# Minimum Operational Performance Standards (MOPS) for Traffic Alert and Collision Avoidance System II (TCAS II) Hybrid Surveillance

Change 1

RTCA DO-300A Change 1 December 15, 2015 Prepared by: SC-147 © 2015, RTCA, Inc.

Figure G-1 (Surveillance Tau Modified to 50 seconds)

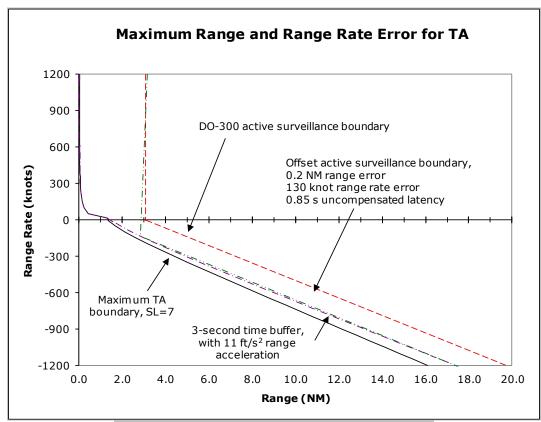
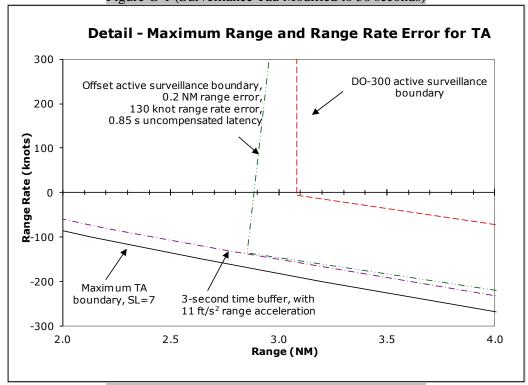
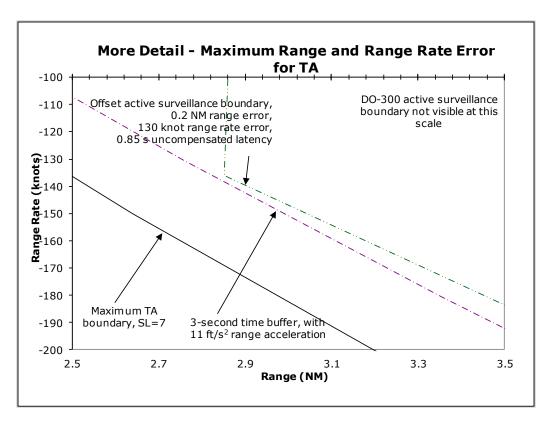
Analysis shows that even if the active surveillance boundary were modified to be 59 seconds to account for the one second delay in transitioning to SUVMODE = NORMAL that the dashed green curve would not "touch" or cross below the dashed purple curve — which represents the 3 second buffer to allow adequate time for a TA. In fact, even if the surveillance transition tau were changed to 50 seconds the 3 second TA buffer and 8 second RA buffer would be maintained. Figures G-1 and G-2 are updates to the curves of Figures D-3 and D-4 but with a surveillance tau threshold of 50 seconds. Figure G-3 is a further scaled in version — so that it is clear that the 3 second boundary is still maintained. If that is still true for a transition that is 10 seconds late that it is certainly true for 1 second delay in the transition.

Figure G-4 (Surveillance Tau Modified to 50 seconds for RA boundary)

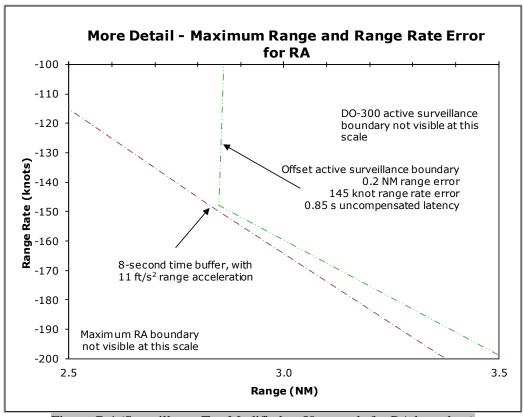
The figure below is a similar detail view – but for the case of the Resolution Advisory boundary at SL=7. As can been seen, the DO-300 active surveillance boundary with assumed errors still does not cross the RA boundary with assumed aircraft acceleration and 8 second buffer.
